## OSM/EE DECISION SHEET

Category	Standard:	Clause	Document no.
ITAV	EN 62368-1:2014 + A11:2017 EN IEC 62368-1:2020 + A11:2020	4.1.5 & G3.5.1	OSM/EE 17.2 rev 2
Subject		Key words	Meeting
Resistor on the primary side as "protective device" (fusible resistors)		Fusible resistor – Primary circuit – Protective device	Zurich 2017 Ljubljana 2019 Helsinki 2024

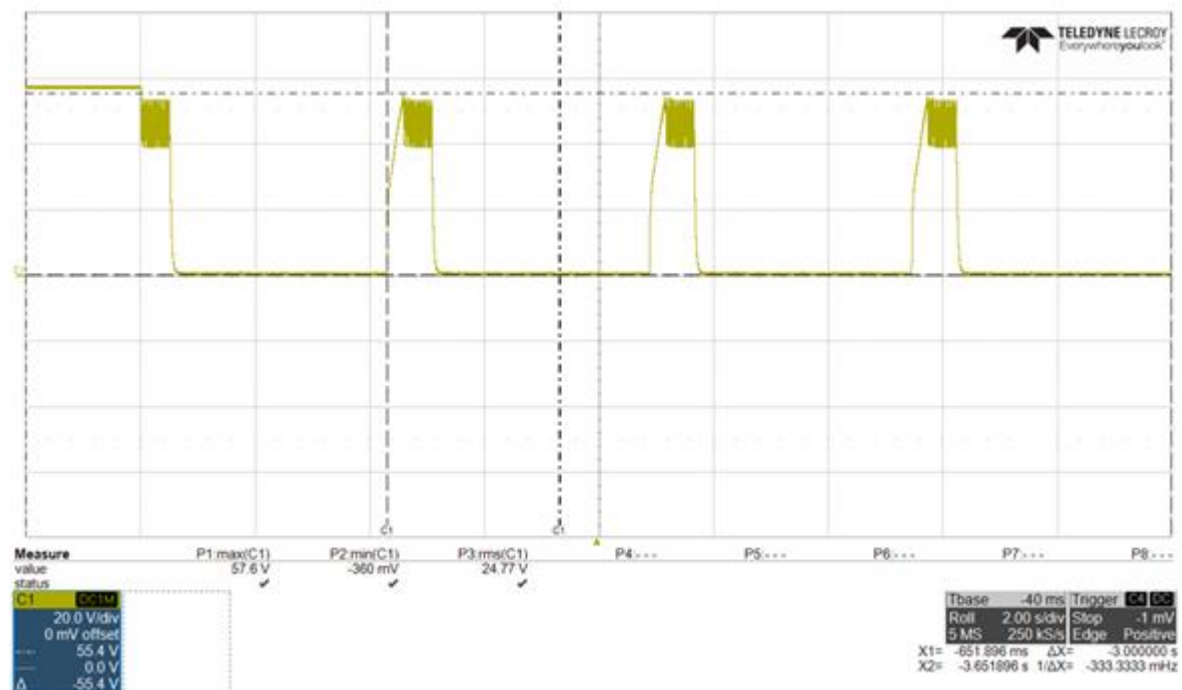
Question			
Standard EN 62368-1 in clause 5.7.4 requires that at least one earthed accessible part shall be subjected to touch current measurement and refers to IEC/EN 60990:1999 (IEC/EN 60990:2016 for the 3rd and 4th editions of EN IEC 62368) for conditions of measurements. a) Is it required to open switch e while conducting relevant faults 6.2.2.2 to 6.2.2.8 (parallel operation of switch e open with other switches)? b) if a) is yes, doesn't this means double fault (fault in earthing and in addition fault in network)?			
Decision

a) YES b) NO, OSM is of the opinion that opening switch "e" is a loss of a safeguard. For measurements on class I equipment switch "e" must be open together with any combination of the other switches in the figure one at the time. Except for the line conductor switch "I" which simulates a line/neutral fault in the installation. If however the equipment contains a single pole mains switch, it shall additionally be tested with the mains switch in the equipment open and closed Confirmed by TC108 at Busan, Korea, Oct 2018			
Explanatory notes			
Switch e simulates opening of protective earthing conductor in non-reliable earthed product. Switch n simulates opening of one pole switch in neutral conductor Switch p simulates polarity connection of the product. Switch I simulates line fault for products connected L to L or 3-phase products Switch g simulates fault in supply system – earthing of one phase in isolated mains system Combination of switch e open together with switch g is not considered as a double fault. Any measurement with switch e closed has no sense. Example of required measurements on product connected L to L of single star IT system (Fig 10 of EN 60990) In Helsinki 2024, OSM-EE decision 18/5 was modified with following changes: - add 3rd and 4th editions of EN IEC 62368-1 - add reference to the latest edition of IEC/EN 60990:1999 - change category from OFF to ITAV

Picture 1 – output hiccup

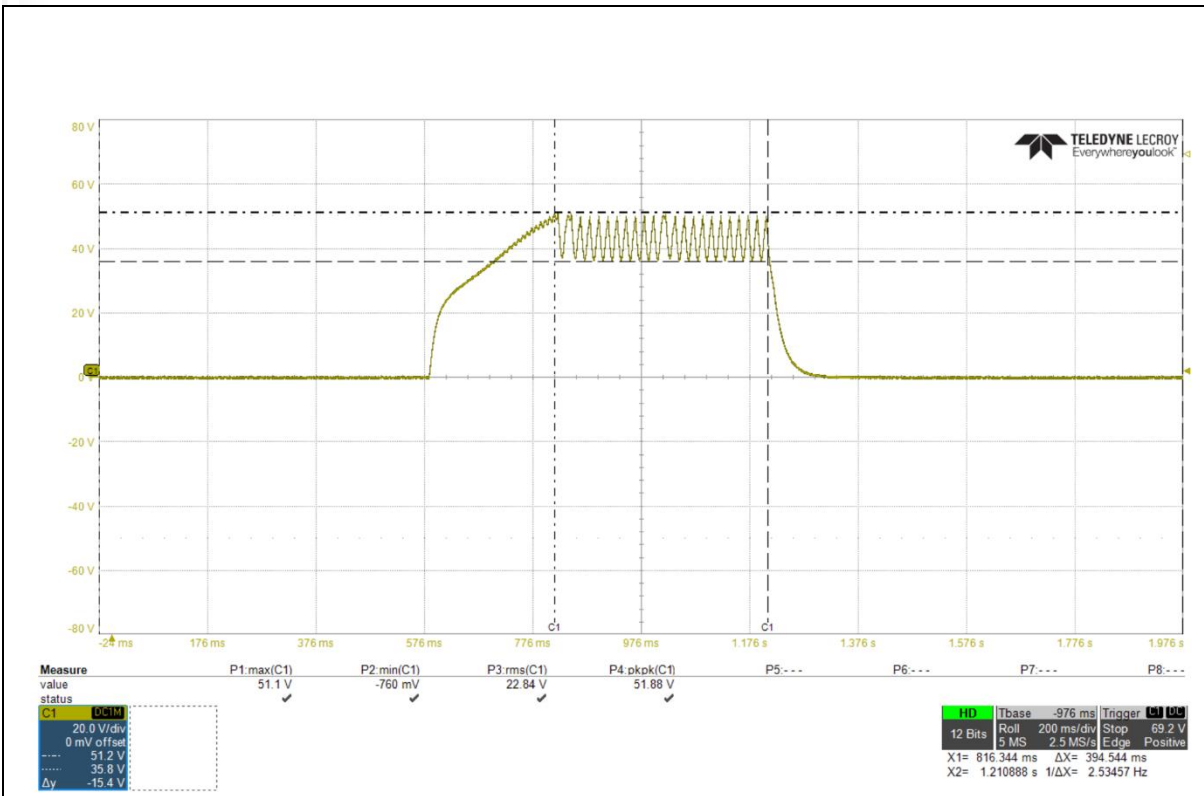
Result of the abnormal operation (output overload) on switch mode power supply, was protective (hiccup) mode with repetitive pulses on the output. Off time between pulses is >3s (see Fig. 1). Each single pulse last for approximately 700msec. Each single pulse has some ringing. The voltage of single pulse does not exceed 60Vpk.

Can such output be classified as ES1?

Yes. The result of the abnormal test is repetitive pulses, therefore clause 5.2.2.5 applies. Since the off time between the pulses is >3s, the limits for single pulse (5.2.2.4) have to be considered. Since the pulse voltage never exceeds 60Vpk, the output can be classified as ES1

Dual loudspeaker plugs supplied by the manufacturer. Case 2:

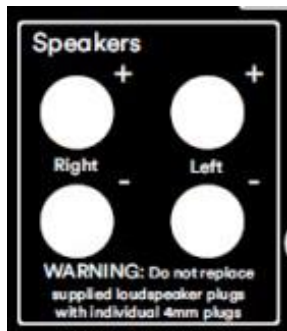
Another solution is also accepted provided that:

the dual loudspeaker plugs have been tested and it is confirmed that the plugs cannot be inserted into a mains outlet and

there is an instructional safeguard on the rear of the amplifier to indicate only use of the dual speaker plugs supplied by the manufacturer. No worded instruction has to be added to the Instructions for Use.
